Guidance for partially-populated MDIs and breakout (comments #86, #87, #107)

Adee Ran, Cisco

“Typical” CR host connectivity (OSFP example)

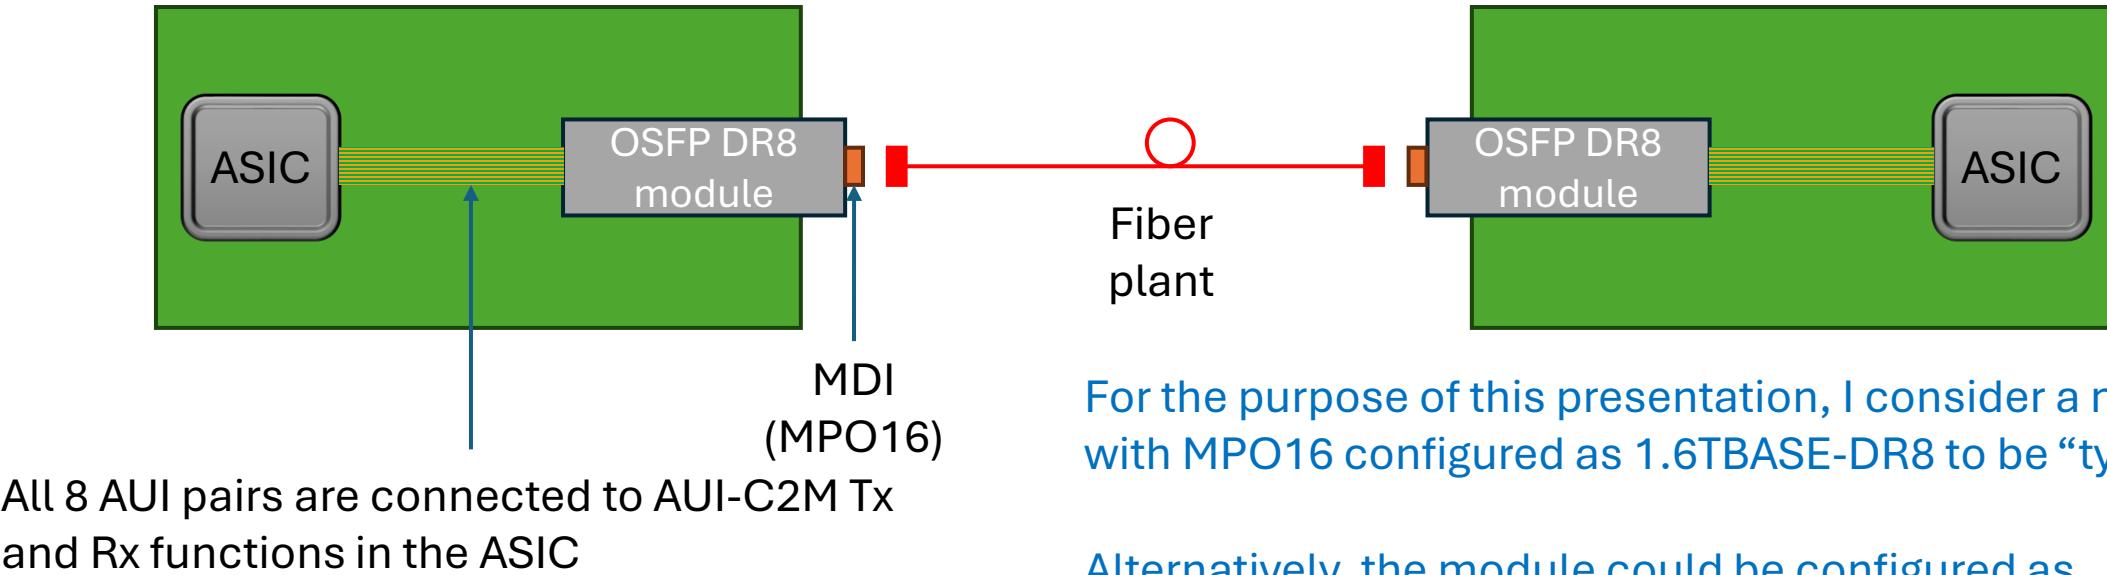
All 8 MDI pairs are connected to PMD Tx and Rx functions in the ASIC

For the purpose of this presentation, I consider OSFP host configured as 1.6TBASE-CR8 to be “typical”

Alternatively, the host could be configured as

- Two 800GBASE-CR4
- Four 400GBASE-CR2
- Eight 200GBASE-CR1
- Or combinations thereof

I consider these as “breakout” configurations. Breakout require different settings for all PHY sublayers (ILT in PMD, PMA, PCS, MAC), which need to be configured.
